MAY 2020 MARINE SOFTWARE UPDATE

PRODUCT UPDATE

Garmin Lock/Pin Code

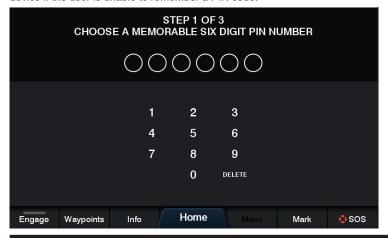
If a user decides to utilize the screen lock, no one will be able to access the device or use any of the features of the device until the appropriate PIN code is entered.

PIN code users must choose and verify a memorable six-digit PIN as well as choosing three PIN recovery questions. Users can select from standard question options or create a unique custom question. PIN recovery questions are required to reset a forgotten PIN code. Garmin will not be able to reset or access any device if the user is unable to remember a PIN code.

Scroll Rate Improvements

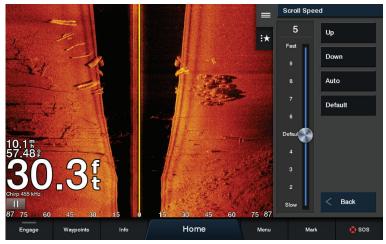
Scroll speed changes were made to improve the clarity of ClearVü and SideVü scanning sonars. Each MFD will scroll sonar at an optimal scroll speed when using the default/normal scroll speed. This removes potential blurriness in the image. Garmin recommends using normal scroll speed, which is scroll rate #5. The default scroll speed value was changed from 4 to 5. Auto scroll speed was improved to have a slightly faster scroll speed.

Improve Awareness of Active Alarms

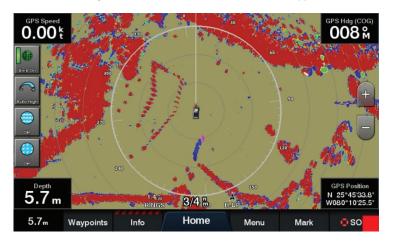
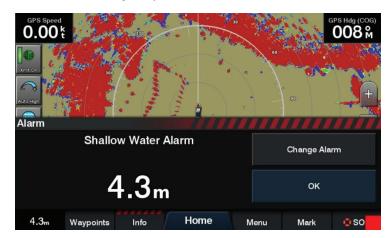
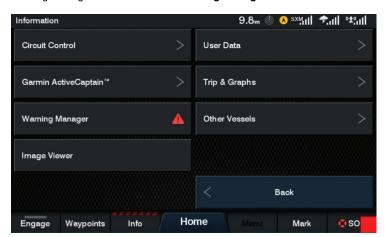
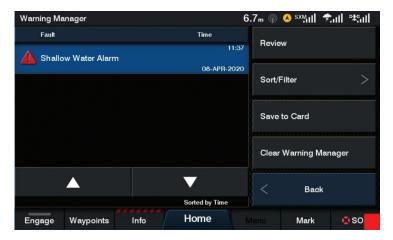
For most red and yellow level alarms, a series of LEDs will appear above the Info button on the SCC. This light stays there until the error conditions clear.

If a user clicks on the **Info** button, they will see an icon on the warning manager that matches the color of the LEDs. To clear the alarm, the user must go into the warning manager and select **Clear Warning Manager**.
